工程指示 / 要求簡箋(E.I.)

工程名稱：將軍澳日出康城 11

工程項目：幕牆單元件 水槽料保護鋁蓋 (鋁摺件不用鉻化) 樣板 地盤用

Subject: **Site Observation for Make Use of Wooden or Plastic Cover for Gutter Water Test (2nd Reminder)**

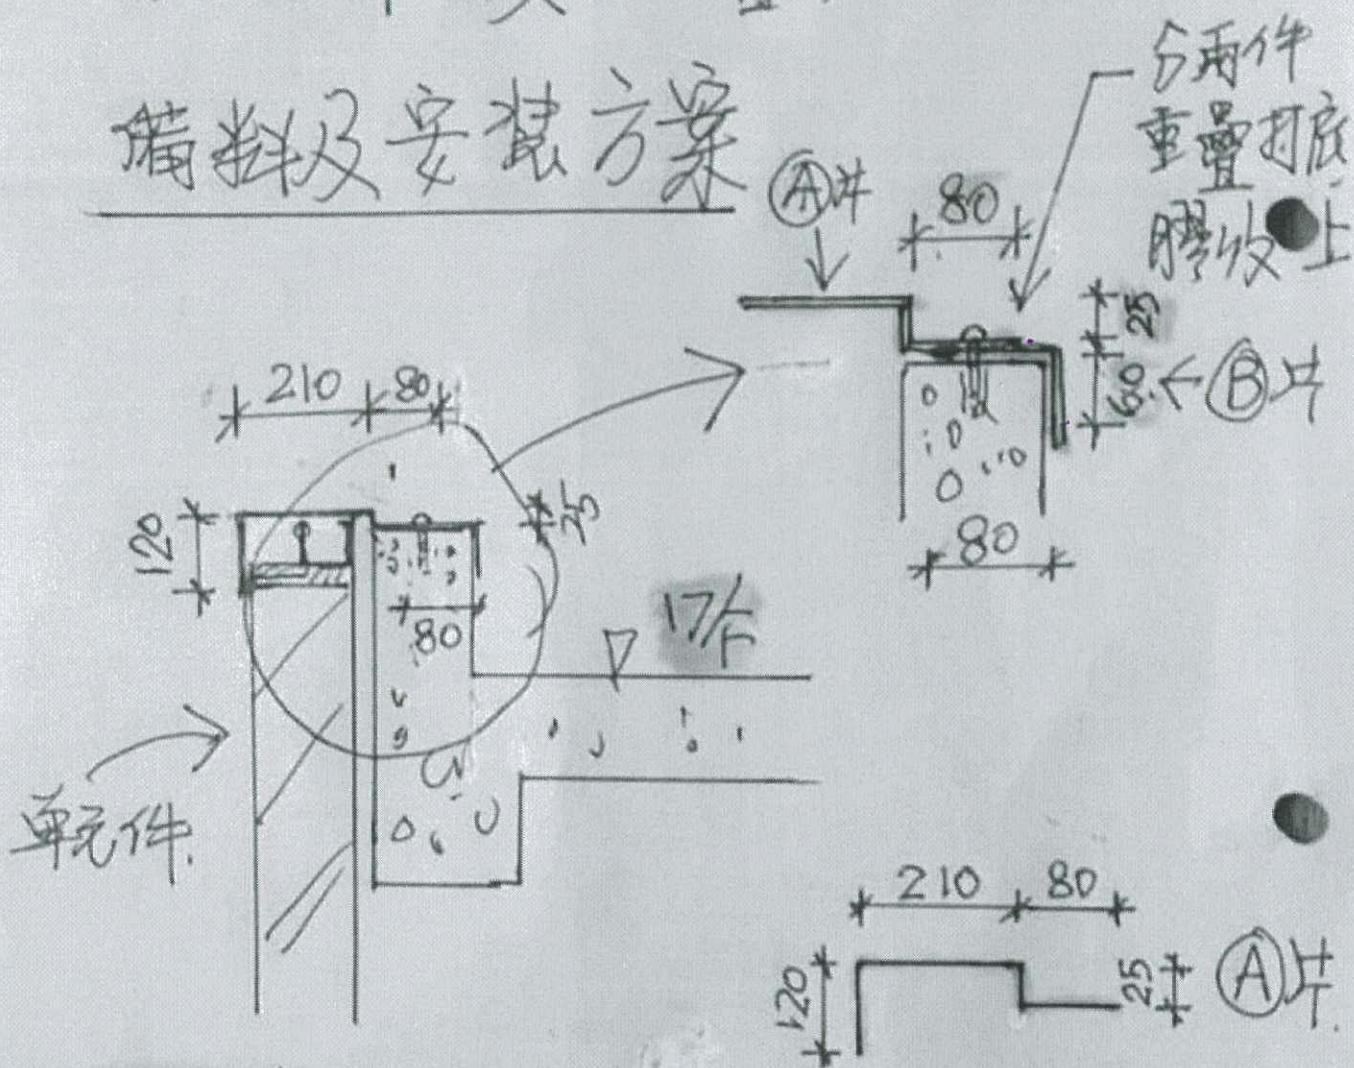
請按圖生產水槽料保護鋁蓋 (鋁摺件)

→ 先做樣板 A 款 36 件， B 款 36 件

L=2400mm

1.2mm 厚，不用鉻化 (臨時保護水槽料用)

因安裝後，頂部曝露多時需要保護。

Photo 2

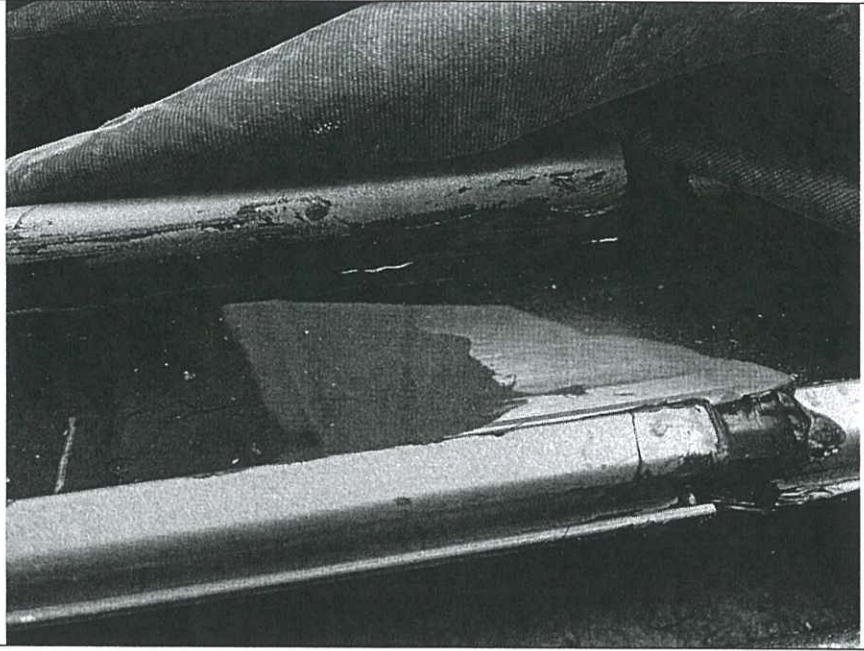
The canvas was observed to be used during units gutter water test, we recommend using wooden or plastic cover as tidy method for elimination of ambience influence.

Photo 3

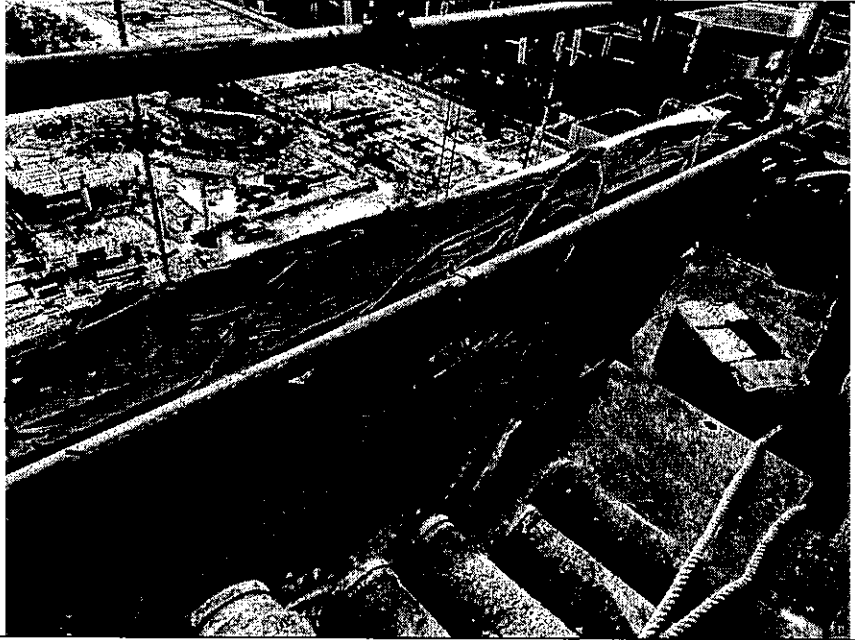
The canvas was observed to be used during units gutter water test, we recommend using wooden or plastic cover as tidy method for elimination of ambient influence.
